ADDENDUM #1 - 6/16/2025
REVISED SHEETS: D-1, D-2, D-7, INT-2, INT-3, P-1, P-2, P-4, U-1, U-2, U-3, U-5, W-1, W-2, W-5, W-7, E-1, E-2, E-4, E-7, AND E-8.
REVISION #1 - 8/28/2025
REVISED SHEETS: D-6, INT-2, INT-3, INT-4, INT-6, INT-7, P-1, P-2, P-3, P-4, P-5, P-6, U, W, E, AND ALL X SHEETS.
REVISION #2 - 11/10/2025
REVISED SHEETS: D-6, D-7, INT 1 - INT 4, INT-6, P-1, P-2, P-4, U-1 - U-7, U-12 - U-15, W-3, X-1 - X-7, X-9, AND X-10.
REVISION #3 - 02/20/2025
REVISED SHEETS: U-1, U-4, U-13, U-14, W-1, AND W-7.
REVISION #4 - 04/24/2026
REVISED SHEETS: D-6, INT 1 - INT 4, P-1, P-2. P-4, U-13, X-3 - X-6, AND X-11.

E. MAIN STREET & S. HANCOCK STREET
ASSESSMENT DISTRICT - 2025

CITY PROJECT NO. 15125
CONTRACT NO. 8784

TYPICAL SECTION
E. MAIN ST.
(S. WEBSTER ST. TO S. BUTLER ST.)

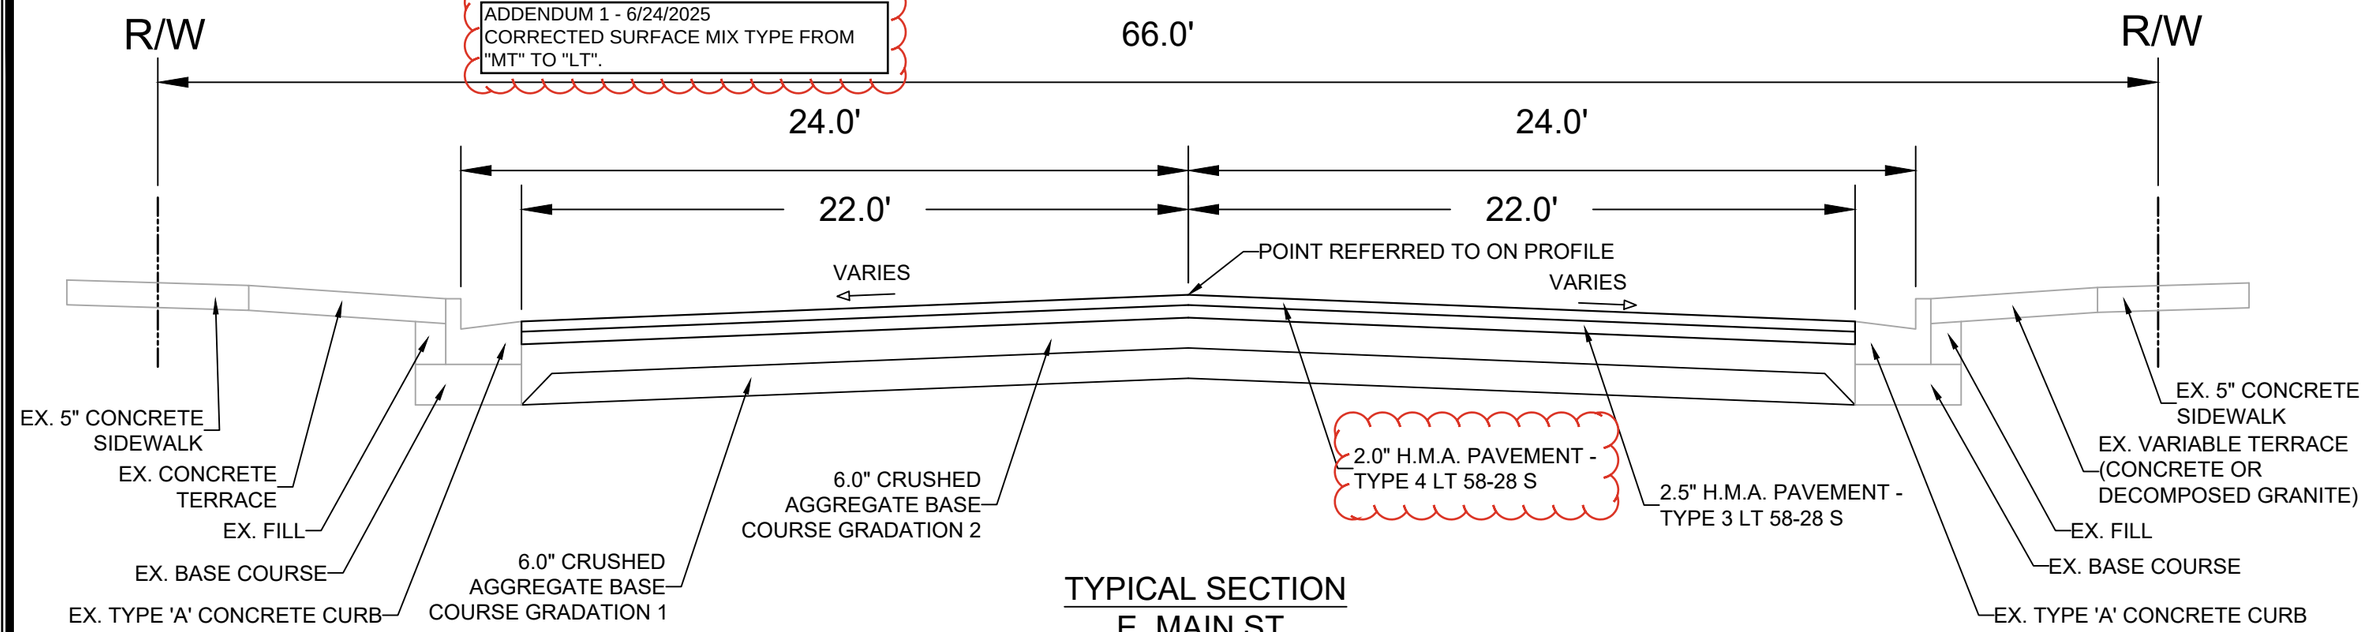
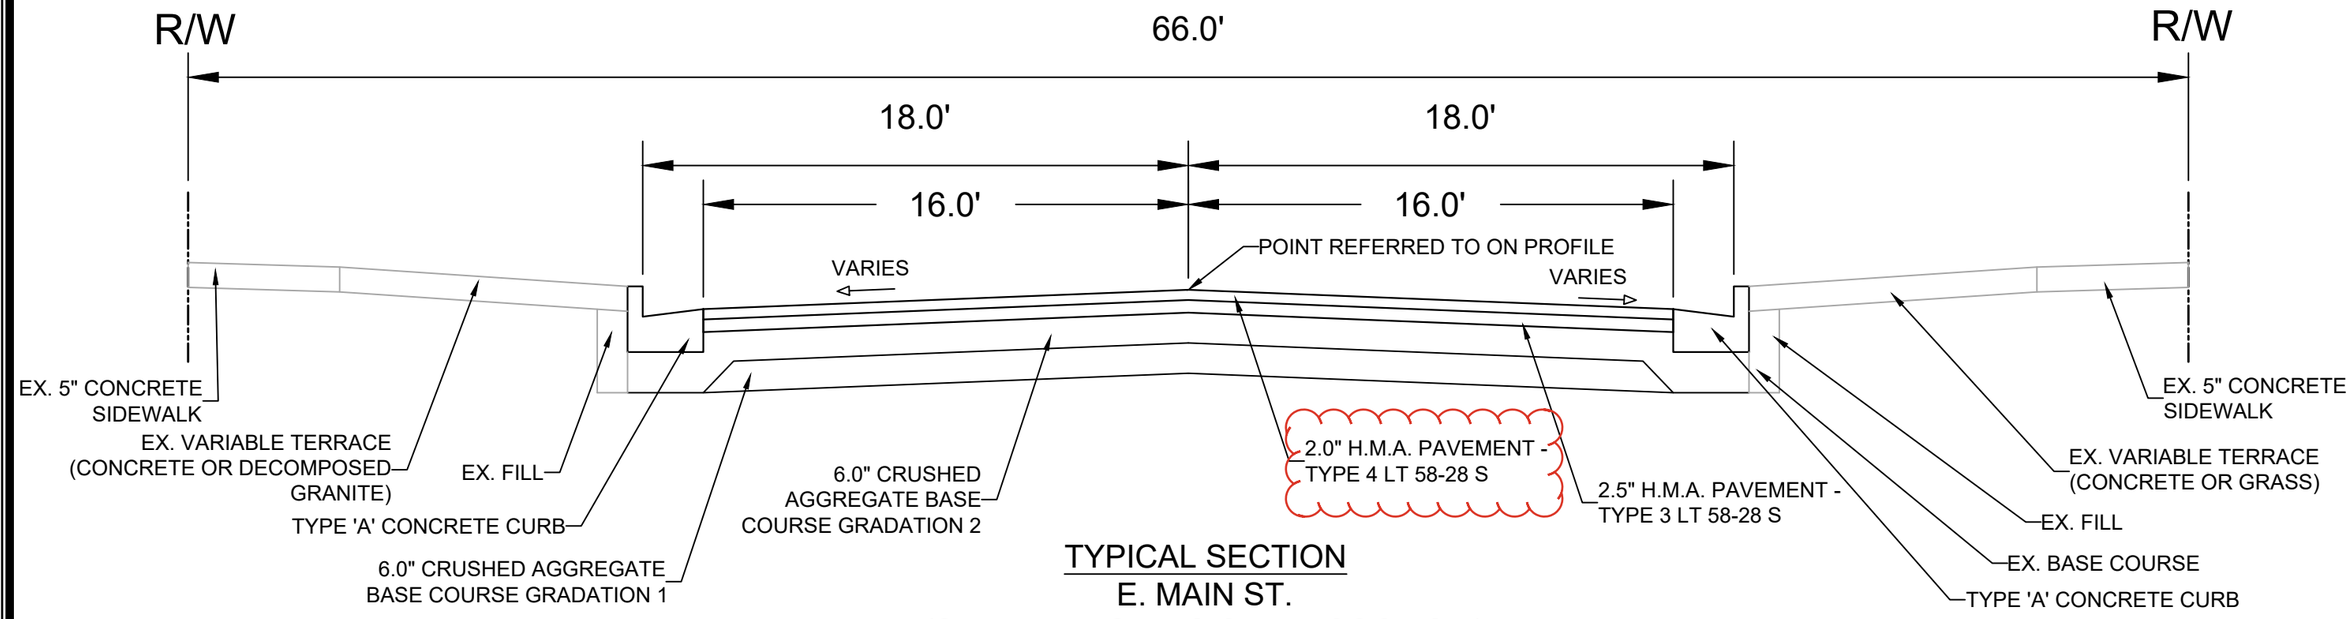
ADDENDUM 1 - 6/24/2025
CORRECTED SURFACE MIX TYPE FROM "MT" TO "LT".

TYPICAL SECTION
E. MAIN ST.
(S. HANCOCK ST. TO S. FRANKLIN ST.)

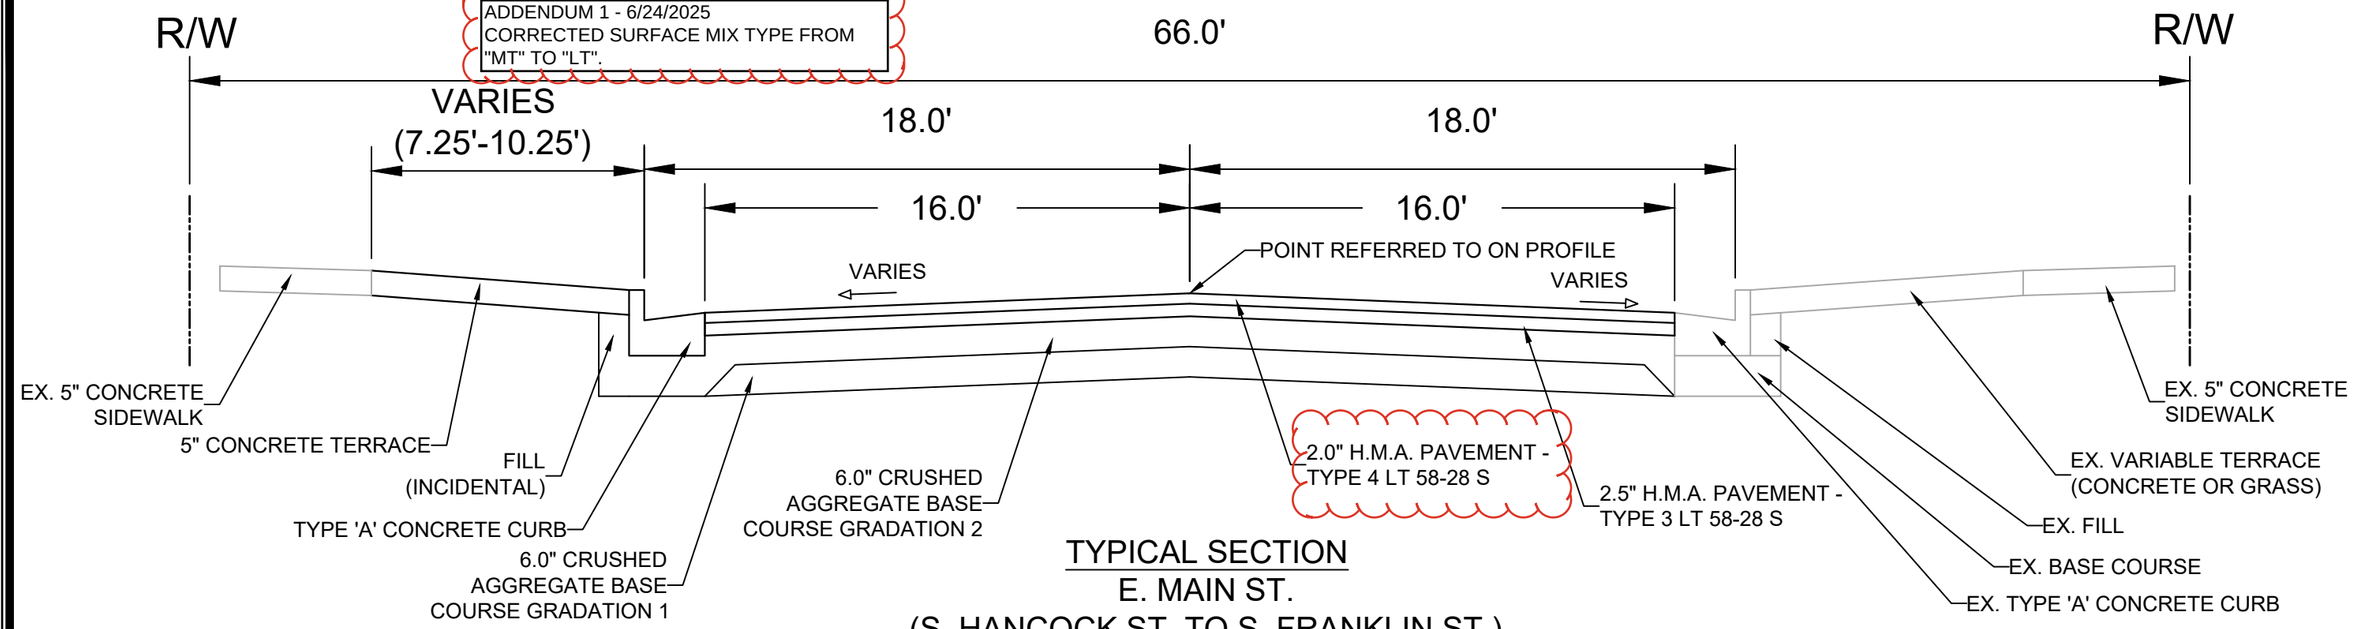
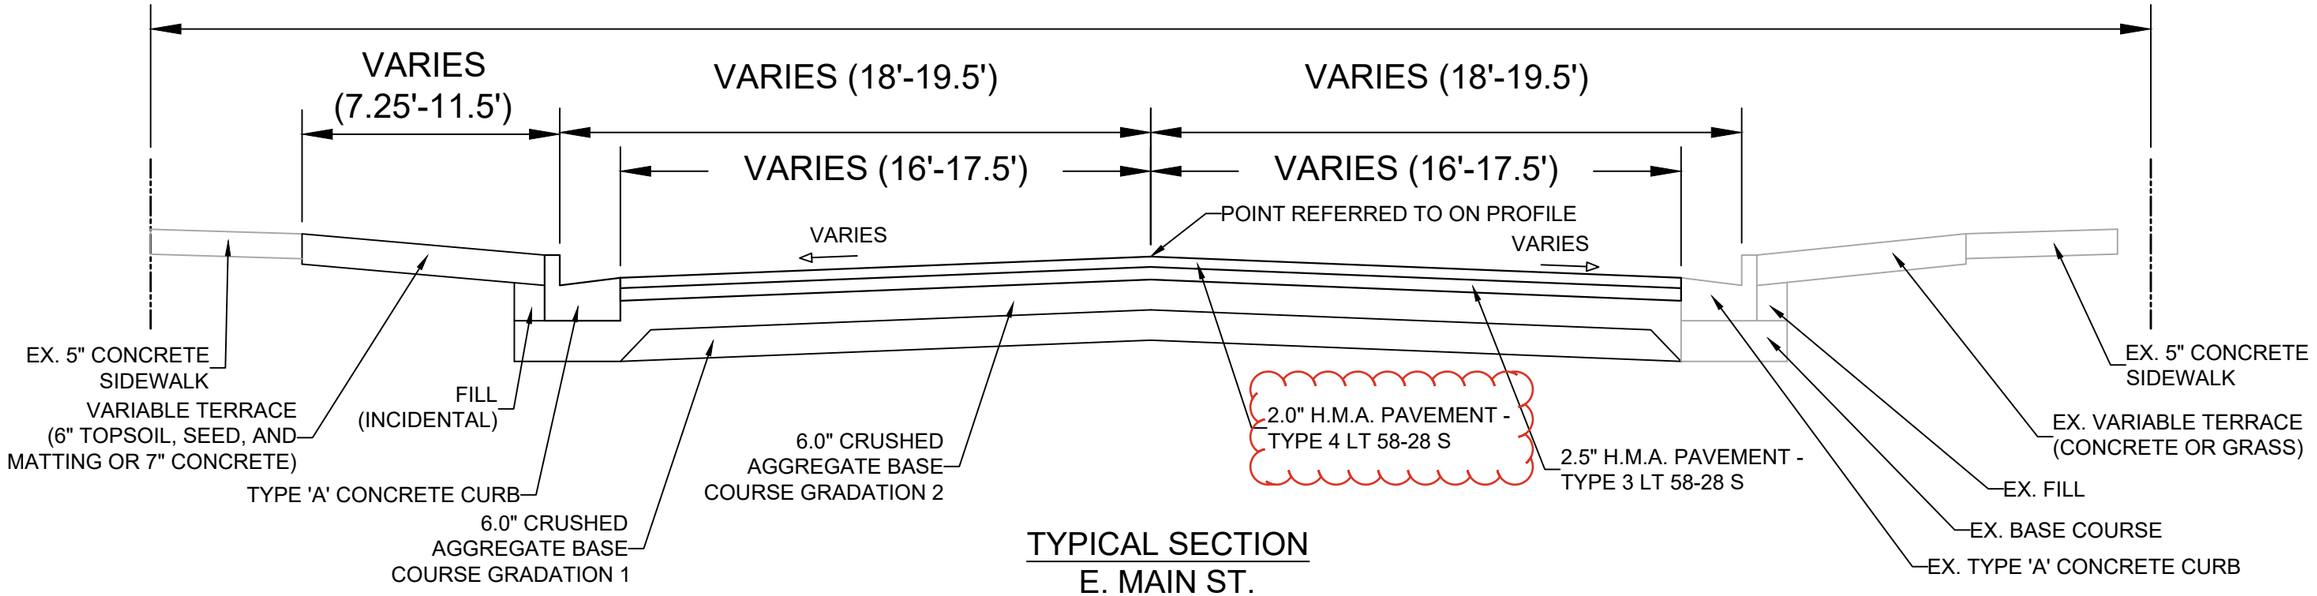
ADDENDUM 1 - 6/24/2025
CORRECTED SURFACE MIX TYPE FROM "MT" TO "LT".

DETAIL: TSS-1, TSS-2, TSS-3

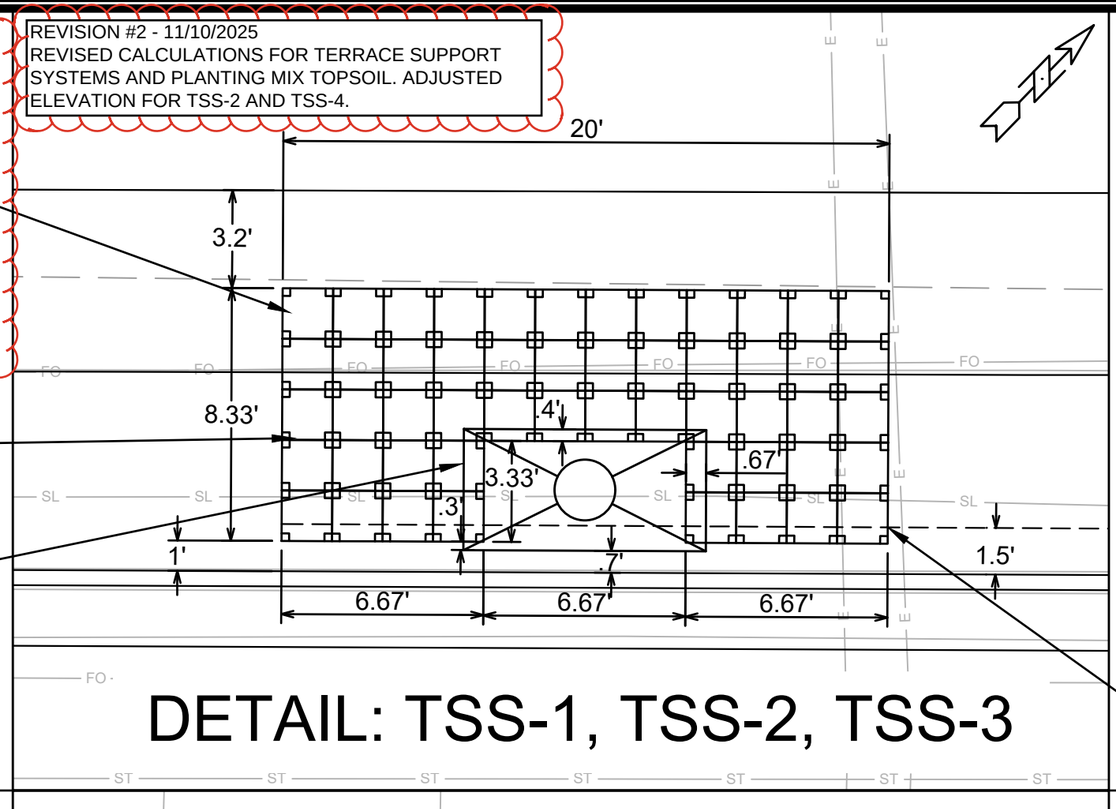
REVISION #2 - 11/10/2025
REVISED CALCULATIONS FOR TERRACE SUPPORT SYSTEMS AND PLANTING MIX TOPSOIL. ADJUSTED ELEVATION FOR TSS-2 AND TSS-4.

PLAN & PROFILE - S HANCOCK ST

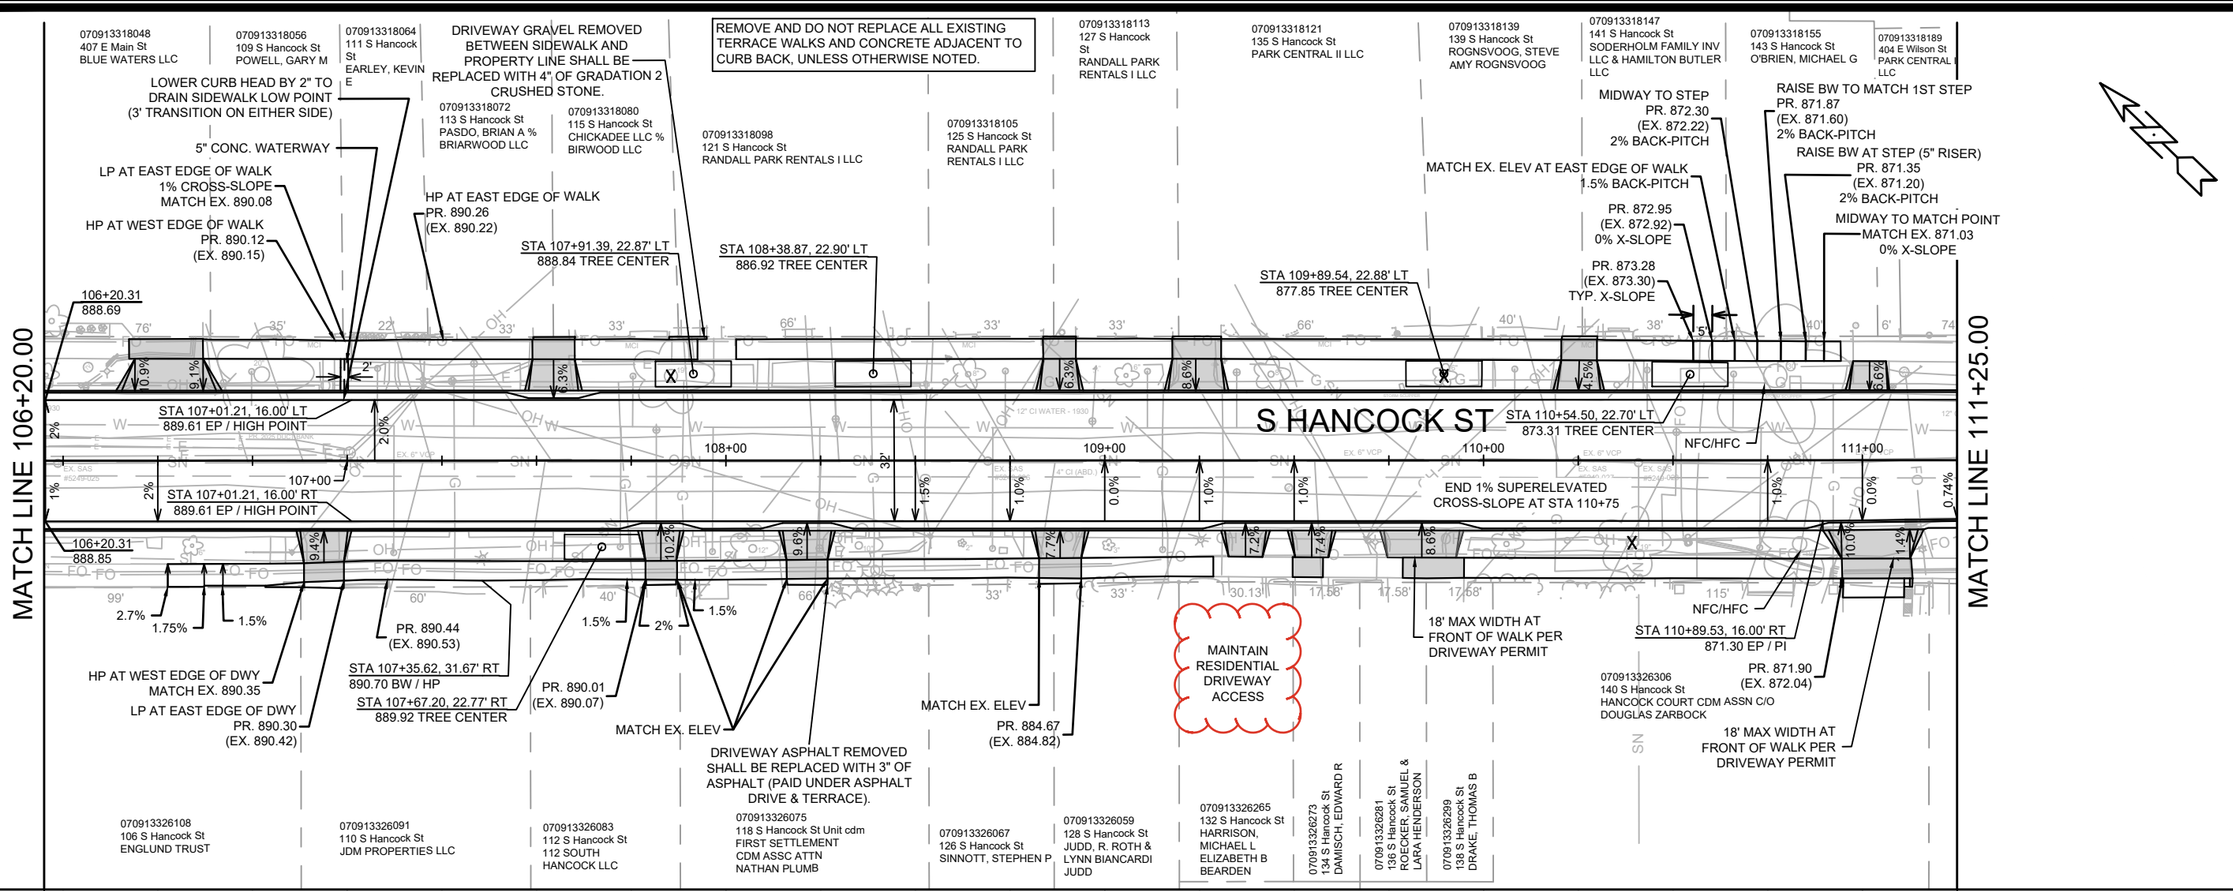
REVISION #1 - 8/28/2025
CHANGED CENTERLINE AND CURB GRADES, INCREASED SIDEWALK REMOVAL, CHANGED CROSS SLOPES, AND ADDED "MAINTAIN RESIDENTIAL DRIVEWAY ACCESS" FOR 132 S HANCOCK ST.

E MAIN ST - PLAN & PROFILE

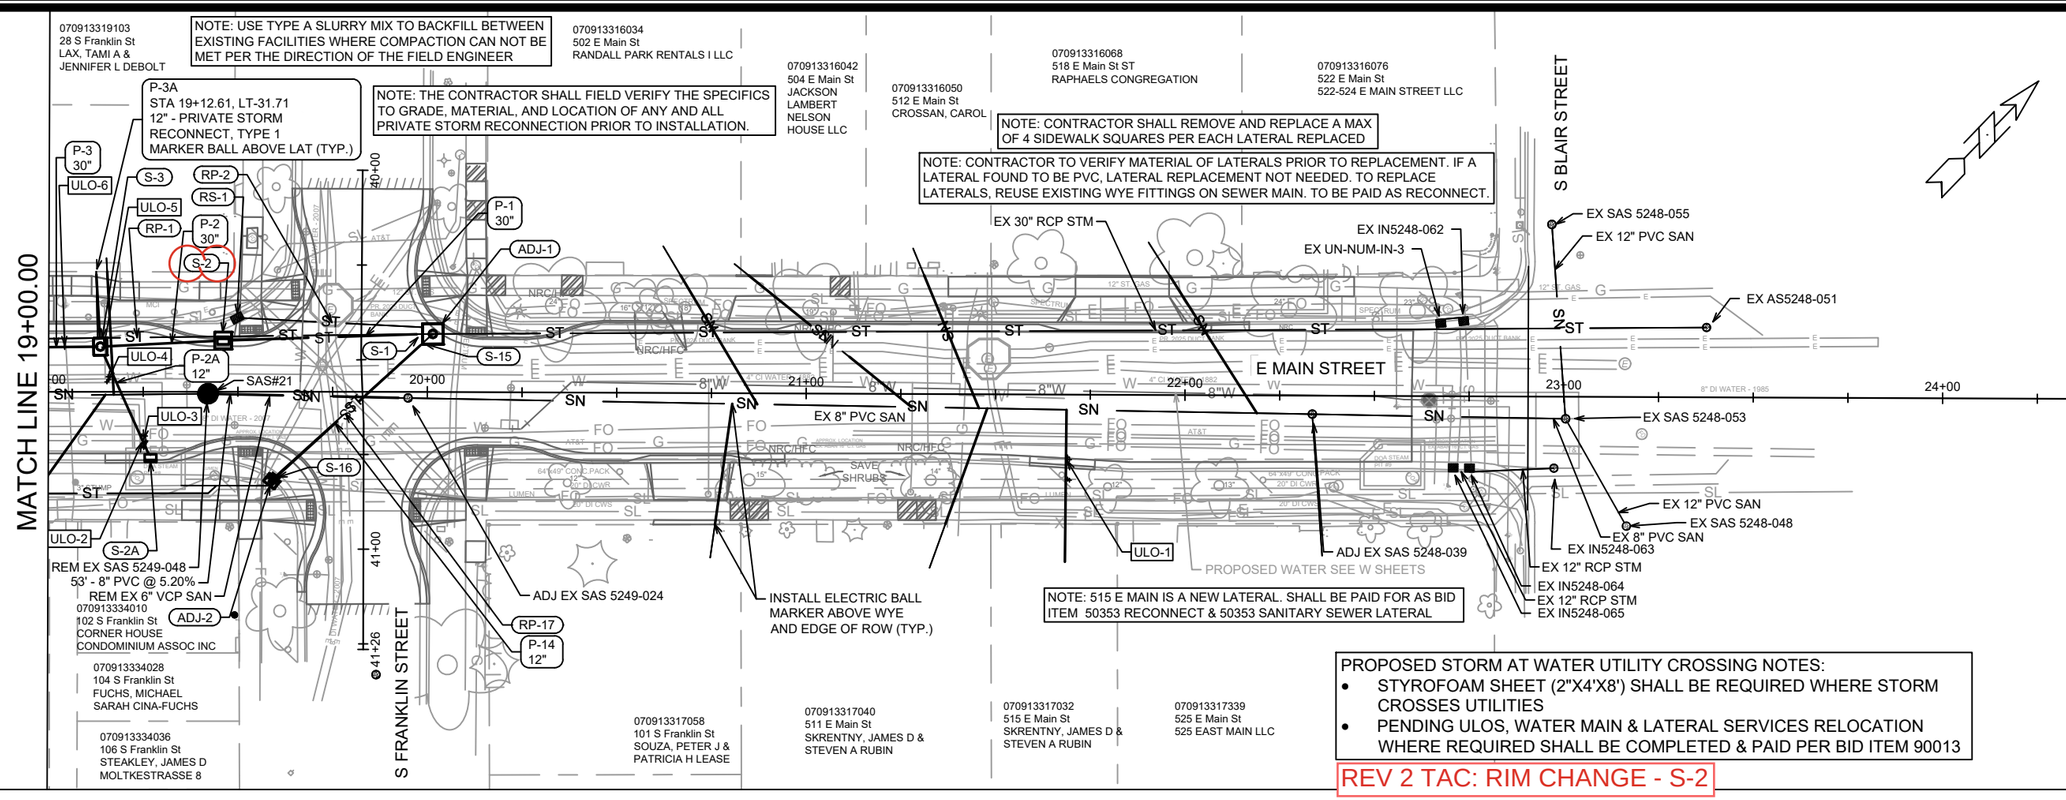
MARK	DATE	BY
---	---	TAC
---	---	TAC
REVISION 2	8/28/2025	TAC
REVISION 1	6/24/2025	TAC
ADDENDUM 1		
REVISION
